# Access Compliance Report

## Public Rights-of-Way

Intersection ID: 12977	Main Street: W_PALMER_ST	Cross Street: S_CHURCH_ST	Location: SW
ADA ID: 5BA6533A7E2F	Ramp Type: Perp	Initial Pass/Fail: Fail	Overall Compliance: No
Severity Score: 25			
Codes/Mitigation Info/Possible Solution		Field Measurements/Component Compliance

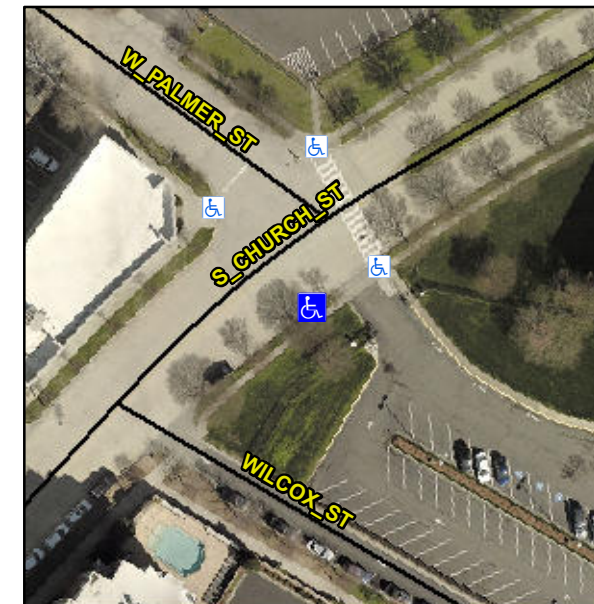
**Not Found, R304.2.2, R304.5.3**

Compliance	Description	Data	Compliance	Description	Data
N/A	Ramp Length (in)	49.0	No	Ramp Slope (%)	9.8
Yes	Ramp Width (in)	48.0	No	Ramp XSlope (%)	6.4
N/A	Flare Type LT	N/A	N/A	Flare Type RT	N/A
N/A	Flare Slope LT (%)	N/A	N/A	Flare Slope RT (%)	N/A
N/A	Flare Traversable LT?	N/A	N/A	Flare Traversable RT?	N/A
N/A	Landing Length (in)	N/A	N/A	DWS Provided?	N/A
N/A	Landing Width (in)	N/A	N/A	DWS Contrast?	N/A
N/A	Landing Slope (%)	N/A	N/A	DWS Length (in)	N/A
N/A	Landing X Slope (%)	N/A	N/A	DWS Full Width?	N/A
N/A	Landing Curb? (Y/N)	N/A	N/A	DWS Offset (in)	N/A
N/A	Shared Landing?	N/A			
N/A	Gutter Ponding?	N/A	N/A	Gutter Slope (%)	N/A
N/A	Gutter Lip Ht (in)	N/A	N/A	Gutter X Slope (%)	N/A
N/A	Painted X Walk1?	No	N/A	Painted X Walk2?	N/A
	X Walk 1 Direction	To NW		X Walk 2 Direction	N/A
N/A	X Walk 1 Width (in)	N/A	N/A	X Walk 2 Width (in)	N/A
	X Walk 1 Slope (%)	2.3		X Walk 2 Slope (%)	N/A
	X Walk 1 X Slope (%)	1.7		X Walk 2 X Slope (%)	N/A

**Remove & Replace Entire Ramp.**
